SAWTOOTH SERENADE

Project: **SAWTOOTH SERENADE**
260 N 1ST AVE
KETCHUM, ID

COMMENT RESPONSE A

Sheet Title:
COMMENT RESPONSE C

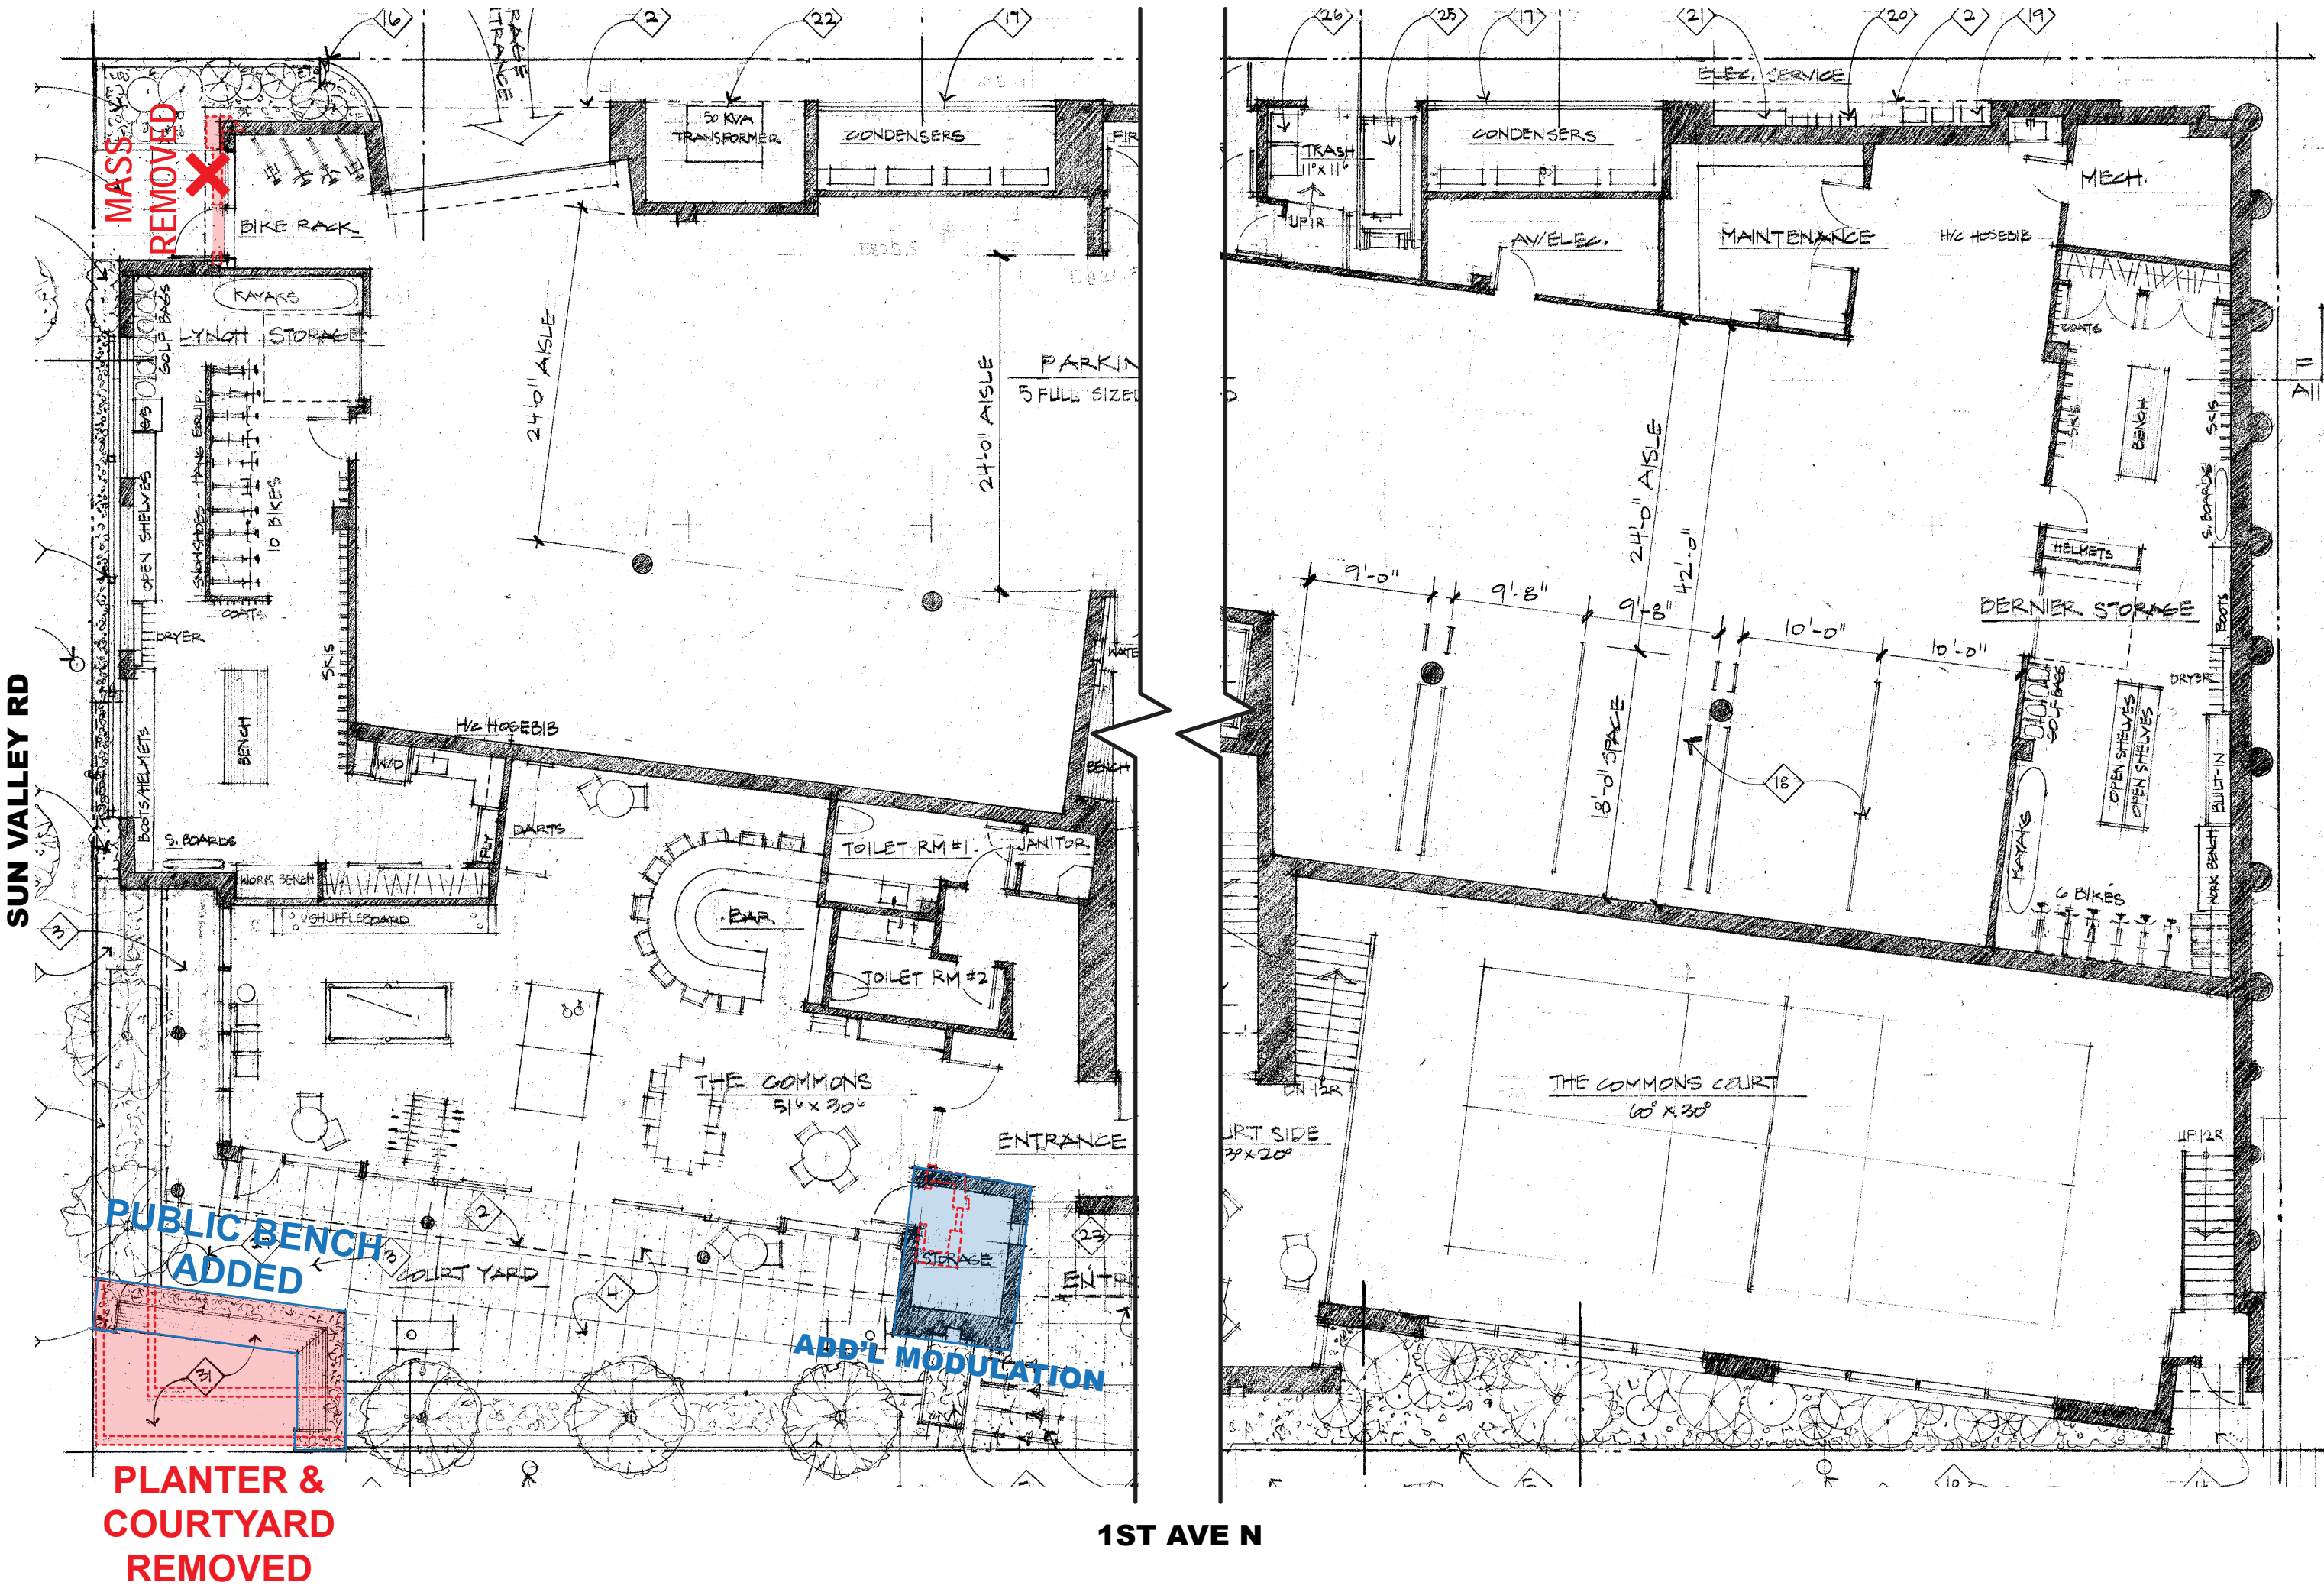
DESIGN REVIEW COMMENTS
All of the wood siding on the northeast corner of the building. There is something about that corner that is a little unsettling. I don't know if it is the jogs in the roof plane. Somehow it's just not very grounded.
-Brenda Moczygemba

This is just a large plane of glass. (in reference to the upper level glazing)
-Brenda Moczygemba

"This is just a large plane of glass."
-Brenda Moczygemba

- 1 The south wall of the Lynch's bedroom was pulled back from N 1st Ave to break up the wall plane of the upper level and introduce more modulation to that face. The roof line at the northwest corner was lowered and simplified to bring more solidity to the composition. This also significantly reduced the building's bulk when viewed from Sun Valley Rd as the facade is now 2' shorter than it was previously. The simplification of the roof line now emphasizes the modulation, in plan and profile, of the west facade which features bays, recessed areas, balconies and significant glazing. These elements create a building which yields a human scale at the pedestrian experience.

- 3 The central portions of the facade, adjacent to the stair, were pulled back from the Great Room walls to add modulation. On the Bernier's side, the wall and window in this area were deeply recessed below an overhang. The Lynch's side features a sunshade canopy over the windows

- 4 The height of the Bernier's bedroom volume was reduced. The south wall was brought towards N 1st Ave and a wrap-around sunshade was added to further break up the plane and introduce more articulation to the upper level.

- 3C The massing on the Berniers' home has been greatly reduced along the zero lot line by shrinking the primary suite area. Resulting in a 5' setback at upper level along the zero lot line. Lastly, windows have been added making the facade more welcoming and residential.

- 4C The Berniers' upper level primary suite deck has been removed to reduce mass along 1st Ave N. Moreover, the exterior wall of the middle level guest bedroom has been set further back from 1st Ave N and the glazing has been reduced. This change also further differentiates the two homes.
